Subject: ENGINE VIBRATION / KNOCKING NOISE / NO.3 ENGINE MOUNT RUBBER BROKEN	Bulletin No: 01-035/07
	Last Issued: 08/08/2007

This bulletin supersedes the previous bulletin 01-021/05 issued on 07/13/05. The DESCRIPTION, APPLICABLE MODEL(S)/VINS, and PART(S) INFORMATION have been revised.

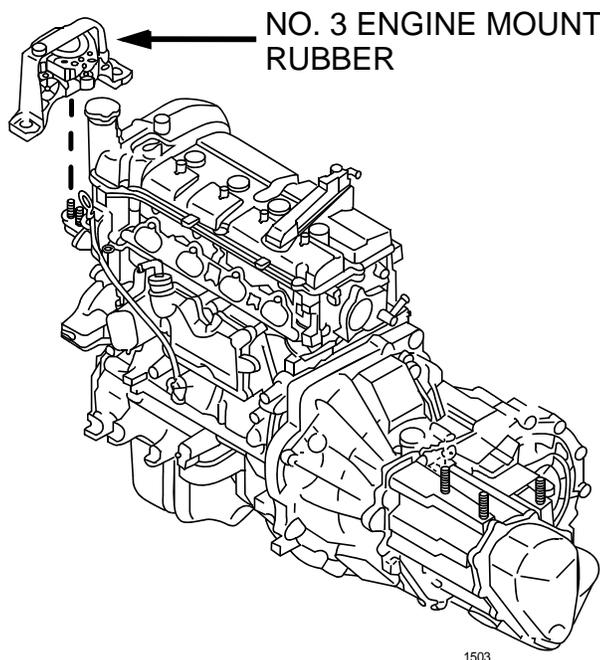
Some vehicles may exhibit a knocking noise from the engine compartment when starting/shutting off the engine or may experience excessive engine vibration at idle. A likely cause of this is a broken No. 3 engine mount. This symptom could be observed under any condition such as accelerating or idling with the engine hot or cold.

The No. 3 engine mount rubber has been modified to address this concern.

1. Verify concern.
2. Replace the No.3 engine mount rubber with a modified part. Refer to Workshop Manual section 01-10.
3. Verify repair.

Part Number	Description	Qty.
BP4S-39-060E	No. 3 Engine Mount Rubber (2.0L)	1
B32T-39-060B	No. 3 Engine Mount Rubber (2.3L)	1
